Form Number: 160.81-M1 (LS05)

LITERATURE SUPPLEMENT

Subject: Revised Wiring Diagram - YR Style A, B & C OptiView Control Panel

**FIG. 9B – LOW VOLTAGE DIGITAL INPUTS**

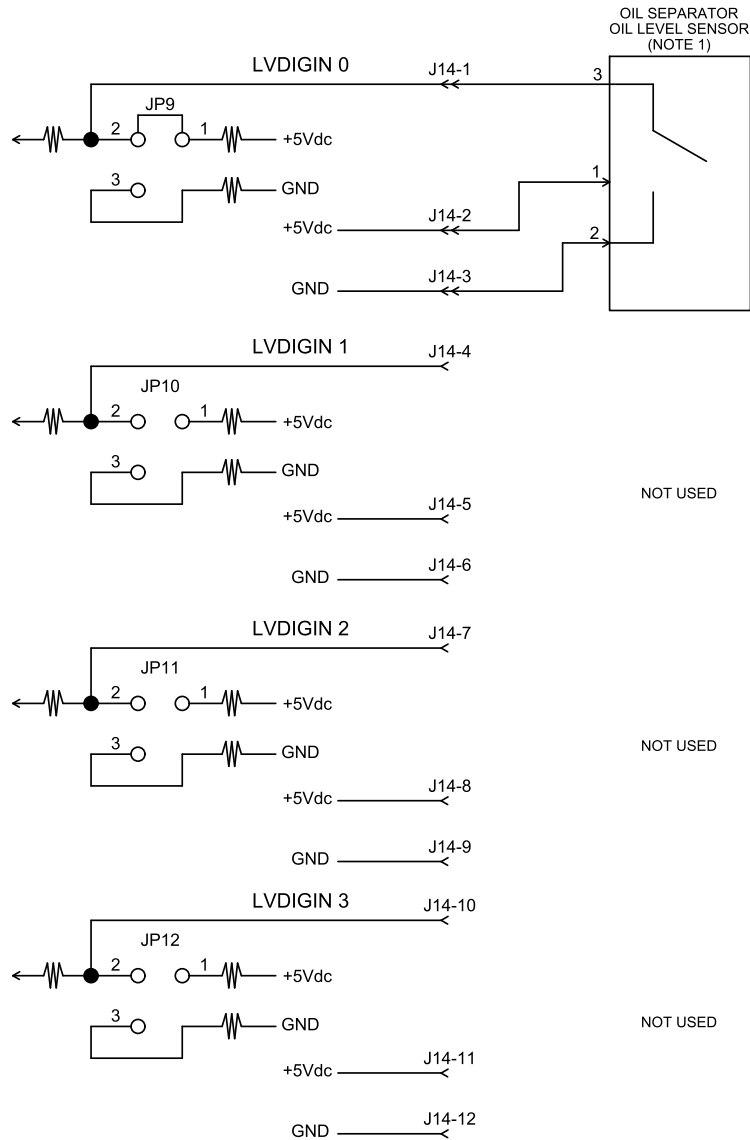
Use the wiring diagram below to replace page 49 in Form 160.81-M1 (507). Note that wire numbers on the oil separator oil level sensor have been revised.

1. New production chillers in late 2007 are equipped with an Oil Level Sensor. Input supported by software version C.OPT.05.08.303 (or later) Sensor is closed with sufficient oil level. It is shown in the faulted condition.
